**Note:** this document should be read in conjunction with the HS2 Tree Panel Terms of Reference

<b>Name</b>	<b>Signature</b>			<b>Date</b>
Application made by:	MDJV				05/12/2022
<b>Location (Sector/Site Name):</b>	Interim Taxi Rank				
<b>LAA/LAP/Site Reference</b>	LP00862_T_F082				
<b>Work Package number:</b>	N/A				
<b>Date of Tree Panel:</b>					16/12/2022
<b>Site Description:</b>	Interim Taxi Rank				
<b>Reason for clearance:</b>	<p>In order to bring in the canopies, we need to have 4-metre clearance from the ground to the top area to allow for the lifting of the canopy into place.</p> <p>In addition, the branches are in the way of the canopy when installed in its final position.</p> <p>A Diagram of the final position is provided. Photograph 2.</p>				
<b>Drawing Reference No.:</b>	N/A but annotated photographs as below section				
	<b>Yes</b>	<b>No</b>	<b>N/A</b>	<b>Comments</b>	
<b>Has the Stage 1 Survey been completed and logged on the Register</b>	X				
	<b>Yes</b>	<b>No</b>	<b>N/A</b>	<b>Comments</b>

**Photograph No 1:** Illustrating view of the tree, indicating the branches that would collide with the canopy structure.

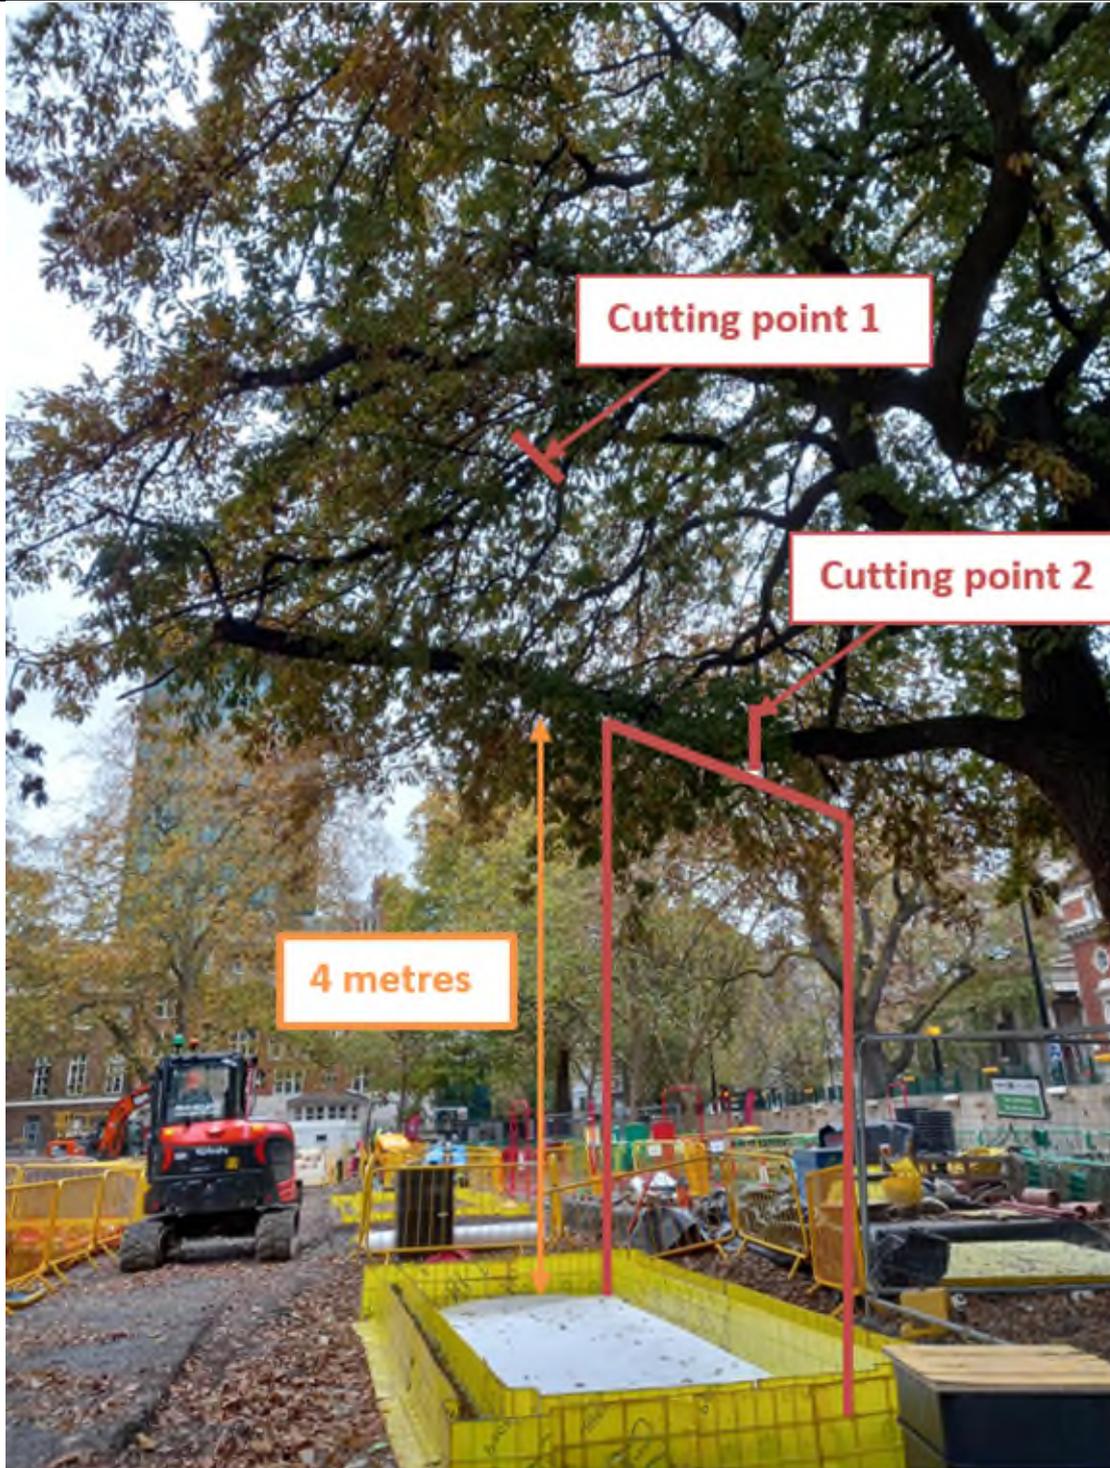
No trees identified for removal. Request to prune 2 two branches from tree LPoo862\_T\_Fo82 under Arboricultural Watching Brief supervision.

Proposal Endorsed/Not Endorsed:	Endorsed
Conditions	N/A
